# 18-067ARB-MPR – DUBLIN TOY EMPORIUM SIGN

Minor Project Review for an existing sign for a tenant located within Historic Dublin.

Approval Minor Project Review with 3 conditions.

**2) Details**

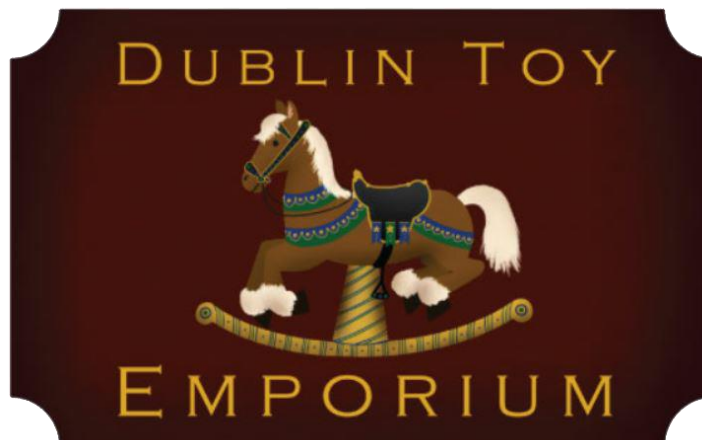
The Code permits projecting signs within the Historic District to be a maximum of 8 square feet in size. A projecting sign approximately half the permitted size is requested with this application. The sign is affixed to an existing wrought iron bracket, which the applicant has indicated is mounted to allow for 8 feet of clear distance below the sign. The applicant will need to submit verification to the Building Standards Division confirming the clear distance below the sign prior to the issuance of a sign permit. Additionally, all mounting hardware should be painted to match the mounting bracket.

Code requires signs to be limited to three colors; however, a logo with multiple colors may count as one of the three colors permitted. The proposed sign includes three colors: brown for the background, goldenrod for the letters, and multi-color for the logo, which meets Code.

The proposed sign panel is a double-faced, 0.5-inch MDO (Medium Density Overlay) plywood sign, which is not a permitted material in the Code. The sign will need to be revised to incorporate an approved material of High Density Urethane (HDU), cedar, redwood, treated lumber, and equivalent materials, as required by Code. The graphic is printed on 3M ControlTac with a UV laminate coating and is subsequently affixed to the MDO.

The Historic Dublin Design Guidelines encourage signs to be fabricated of a high-quality, durable material; and to be finished with paint or carving. The majority of the signs approved throughout the District include a dimensional element. Staff has determined the graphic design of the sign creates the sense of dimension; although, notes this sign is different from what the Board has approved in the past.

- 1) That the applicant use a permitted wood material for the sign background (HDU, cedar, redwood, treated lumber, or equivalent material);
- 2) That the applicant demonstrate eight feet of clear area is provided beneath the sign to be verified by the Building Standards Division at sign permitting; and,
- 3) The sign mounting hardware be painted to match the color of the hanging bracket.
